UNITED STATES
DEPARTMENT OF THE INTERIOR
BUREAU OF LAND MANAGEMENTFORM APPROVED
OMB NO. 1004-0137
Expires: January 31, 2018**SUNDRY NOTICES AND REPORTS ON WELLS**
*Do not use this form for proposals to drill or to re-enter an abandoned well. Use form 3160-3 (APD) for such proposals.***SUBMIT IN TRIPLICATE - Other instructions on page 2**

Gadwall 18 Federal Com #1

Permanent Abandonment of Federal Wells
Conditions of Approval

Gadwall 18 Federal Com #1

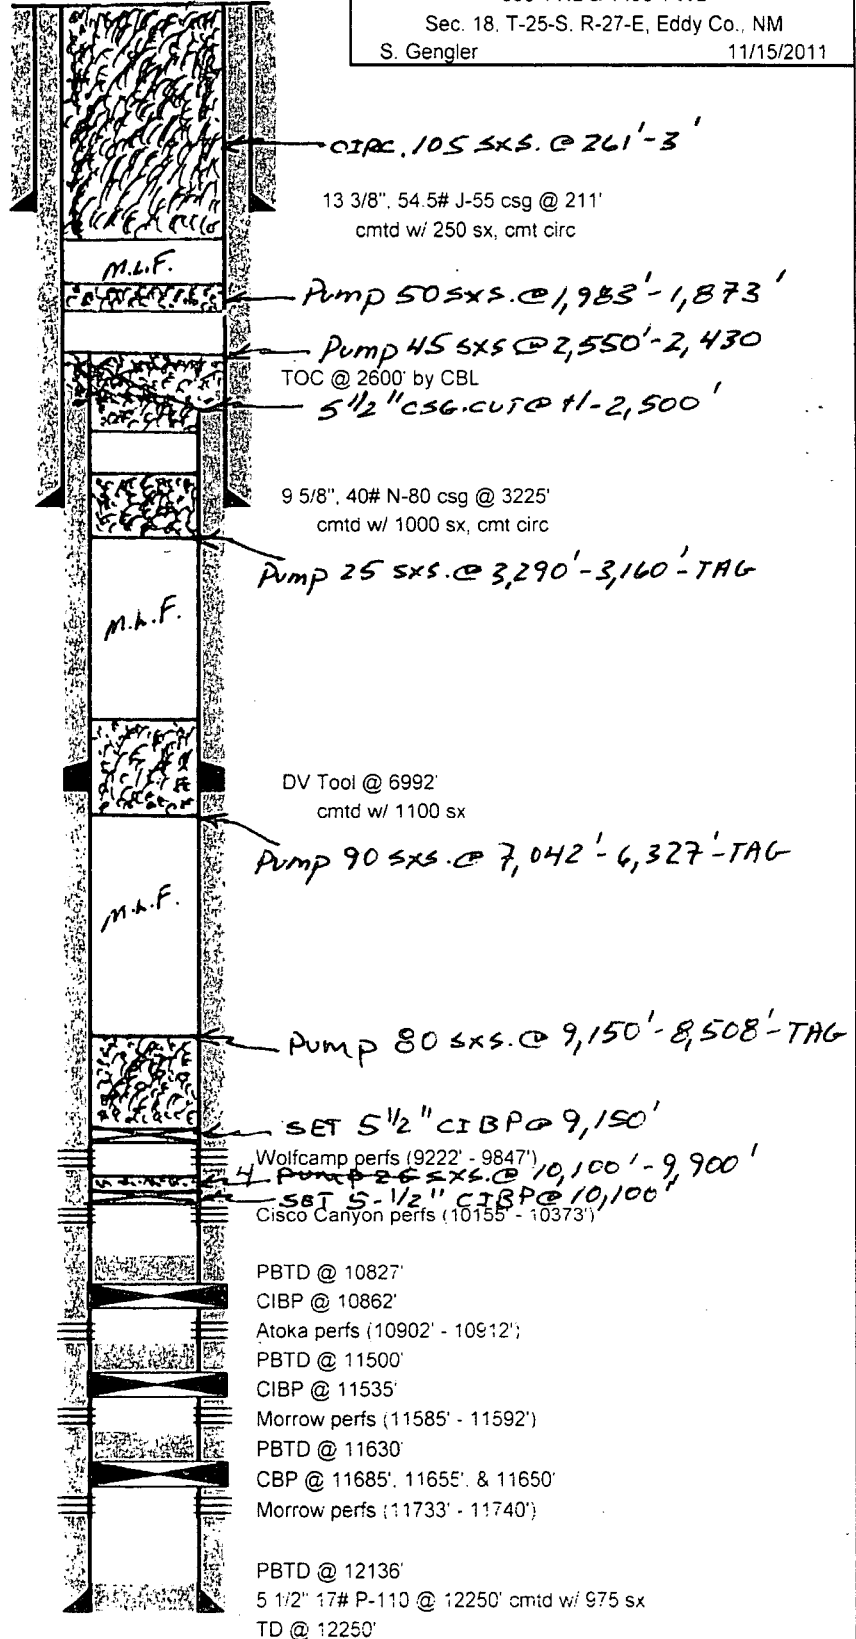
- 1) SET 5-1/2" CIBP @ 10,100'; DUMP BAIL 4 SXS.CMT. @ 10,100'.
 2) SET 5-1/2" CIBP @ 9,150'; PUMP 80 SXS.CMT. @ 9,150'-8,508'(T/WC); WOC X TAG.
 3) CIRC.WELL W/ MLF; PUMP 90 SXS.CMT. @ 7,042'-6,327'(DV TOOL, T/BNSG.); WOC X TAG.
 4) PUMP 25 SXS.CMT. @ 3,290'-3,160'(9-5/8"CSG.SHOE); WOC X TAG CMT. PLUG.
 5) CUT X PULL 5-1/2" CSG. @ +/-2,500'.
 6) PUMP 45 SXS.CMT. @ 2,550'-2,430'(5-1/2" CSG.STUB); WOC X TAG CMT. PLUG.
 7) PUMP 50 SXS.CMT. @ 1,983'-1,873'(T/DLWR.).
 8) MIX X CIRC. TO SURF. 105 SXS.CMT. @ 261'-3'(13-3/8"CSG.SHOE).
 9) DIG OUT X CUT OFF WELLHEAD 3' B.G.L.; WELD ON STEEL PLATE TO CSGS. X INSTALL DRY HOLE MARKER.
 DURING THIS PROCEDURE WE PLAN TO USE THE CLOSED-LOOP SYSTEM W/ A STEEL TANK AND HAUL RETURNS TO THE REQUIRED DISPOSAL, PER OCD RULE 19.15.17.
- (Can Combine)
Add Plug, from 1745-1645 WOC tag & 1180-1080 WOC T. (Salts)

**** BLM REVISED ** BLM REVISED ** BLM REVISED ** BLM REVISED ** BLM REVISED ****
